Access Compliance Report

Public Rights-of-Way

(Curb Ramps)

Intersection ID: 47981	Main Street: SPRINGS_MILL_RD	Cross Street: WHEAT_RIDGE_RD	Location: S
ADA ID: EF6A2D733F87	Ramp Type: PerpDiag	Initial Pass/Fail: Fail	Overall Compliance: No
Severity Score: 8.75			
Codes/Mitigation Info/Possible Solution		Field Measurements/Component Compliance

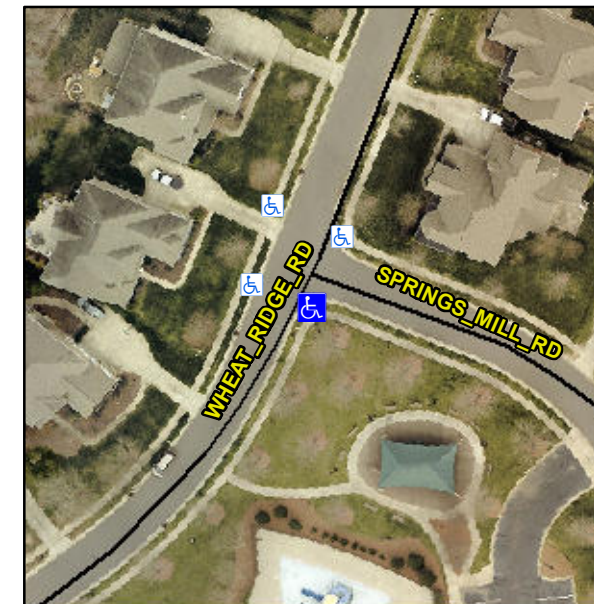
Not Found, R304.5.1

Compliance	Description	Data	Compliance	Description	Data
N/A	Ramp Length (in)	51.0	Yes	Ramp Slope (%)	5.1
No	Ramp Width (in)	43.0	Yes	Ramp XSlope (%)	1.3
N/A	Flare Type LT	N/A	N/A	Flare Type RT	N/A
N/A	Flare Slope LT (%)	N/A	N/A	Flare Slope RT (%)	N/A
N/A	Flare Traversable LT?	N/A	N/A	Flare Traversable RT?	N/A
N/A	Landing Length (in)	N/A	N/A	DWS Provided?	N/A
N/A	Landing Width (in)	N/A	N/A	DWS Contrast?	N/A
N/A	Landing Slope (%)	N/A	N/A	DWS Length (in)	N/A
N/A	Landing X Slope (%)	N/A	N/A	DWS Full Width?	N/A
N/A	Landing Curb? (Y/N)	N/A	N/A	DWS Offset (in)	N/A
N/A	Shared Landing?	N/A			
N/A	Gutter Ponding?	N/A	N/A	Gutter Slope (%)	N/A
N/A	Gutter Lip Ht (in)	N/A	N/A	Gutter X Slope (%)	N/A
N/A	Painted X Walk1?	No	N/A	Painted X Walk2?	No
	X Walk 1 Direction	To NE		X Walk 2 Direction	To NW
N/A	X Walk 1 Width (in)	N/A	N/A	X Walk 2 Width (in)	N/A
	X Walk 1 Slope (%)	3.7		X Walk 2 Slope (%)	2.0
	X Walk 1 X Slope (%)	3.0		X Walk 2 X Slope (%)	1.1

N/A	Ramp inside XWalk1?	N/A	N/A	Ramp inside XWalk2?	N/A
	Road Slope (%)	0.0	N/A	Clear Space?	N/A
	Road X Slope (%)	3.9	N/A	Clear Space to XWalk (in)	N/A
N/A	Any Obstructions?	N/A	N/A	Storm Grate/Utility Hazard?	N/A
	Obstruction Type			Storm Grate/Utility Type	
		N/A			N/A
		Yes		Surface Condition? (G/P)	Good

Remove & Replace Curb Ramp With Two New Directional Ramps or Equivalent.
